## **Proposed CUP Amendment**

Headquarters Exterior Design Proposal

To: City of Columbus Planning Commission  
From: Ben Gutknecht, City Planning Technician  
Date: June 11, 2020  
RE: Bare Home (JP Commerce) Conditional Use Permit Amendment

To: City of Columbus Planning Commission  
From: Ben Gutknecht, City Planning Technician  
Date: July 6, 2020: Revised July 16, 2020  
RE: Interim Use Permit for a Large Off-Premise Sign: Outfront Media

**SOUTH EXTERIOR ELEVATION**

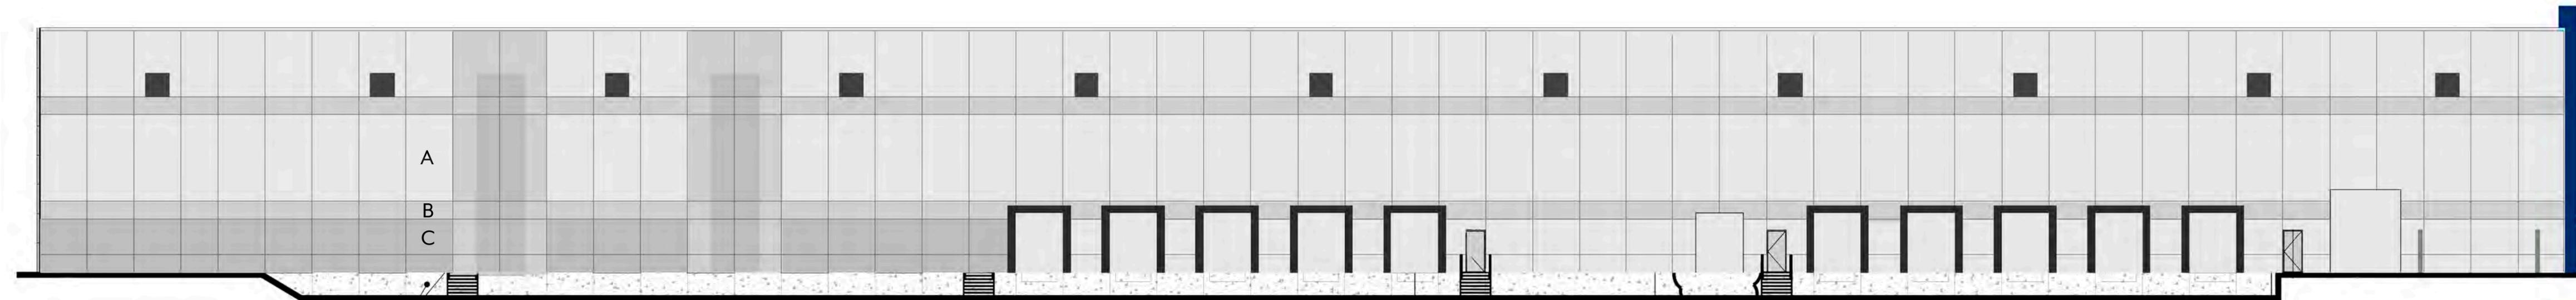
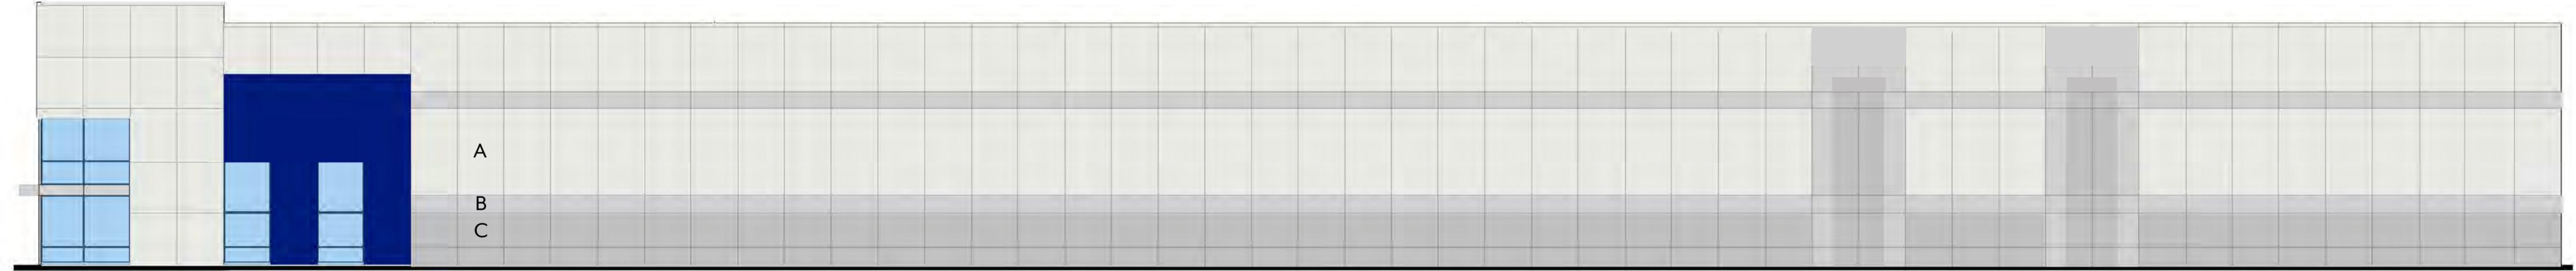
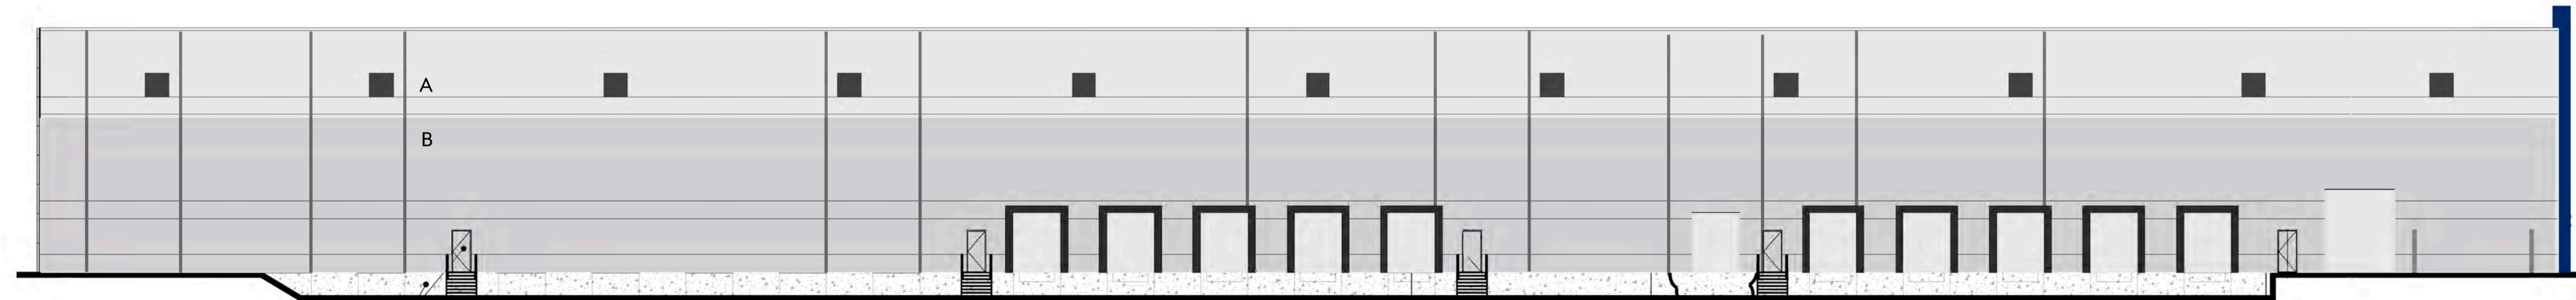
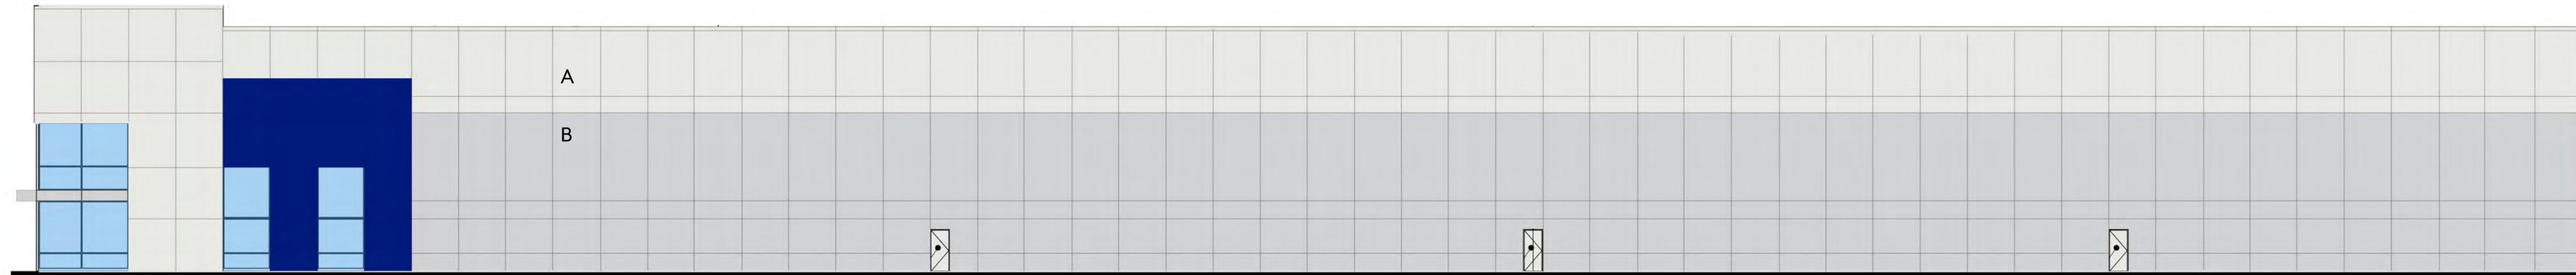
8. The East elevation is not changing from the approved November 25, 2019 building elevations.
9. The blue metal accent and sign, approved in 2018, will also remain as approved.

11. The proposed amendments to the building elevations are consistent with Section 7A-775 of the City Code regarding C/S District Design Standards.
12. The narrative, received 05.11.20, suggests that the landscape plan dated 06.04.20 has been updated to compliment the proposed amended elevation design. The twenty (20) Service Berry trees will break up the bottom one third of the West elevation, and with the addition of meadow prairie plantings Bare Home proposes this will further blend the building into the surrounding environment and continue to support the company’s pollinator friendly initiatives. It appears this revision also facilitates improved visibility of the blue Bare Home sign.
13. The Planning Commission held a public hearing on the Bare Home CUP Amendment Application on June 17<sup>th</sup>, 2020.

8. Development of the Property shall be consistent with the CUP application forms and documentation received for Phase 1 including, but not limited to, Phase 1 Site Improvement Plans, pages 1-11, by Carlson McCain, dated August 13, 2018; floor plans, prepared by Bauer Design Build, dated August 13, 2018; the “Description of proposed Conditional Use”, prepared by JP Ecommerce, undated narrative; the Bare Home CUP amendment application and narrative, dated September 12, 2019; and the second Bare Home CUP amendment application and narrative, dated May 11, 2019 as well as the Building elevations dated May 14, 2020 and updated landscape plans dated 06.04.20.

I-35 PARCEL 2 NORTH BILLBOARD | SB-250'  
COLUMBUS, MN

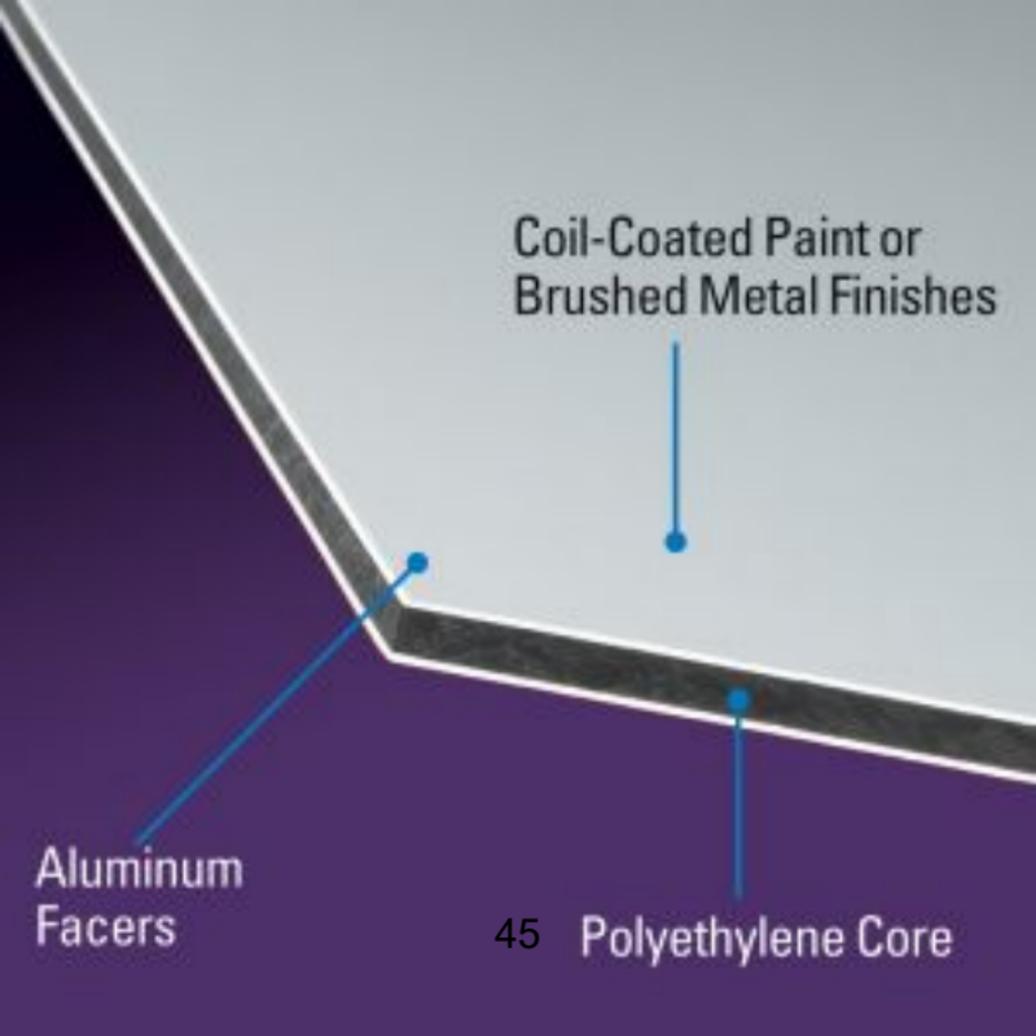
14. The imitation stone is proposed to extend the entire length the support pole, with the oval "Columbus" sign situated near the top of the column. The "Columbus" sign, illustrated on a drawing dated 06.09.20, will be constructed of aluminum with a coil-coated paint or brushed metal finish.

7. The “Columbus” sign shall be placed on the column over at two thirds (2/3) the height of the billboard column.
8. Any plans to convert the static sign to a dynamic sign during the term of this Permit must follow the amendment process outlined in Section 7B-310 (F.3.) of the City Code.
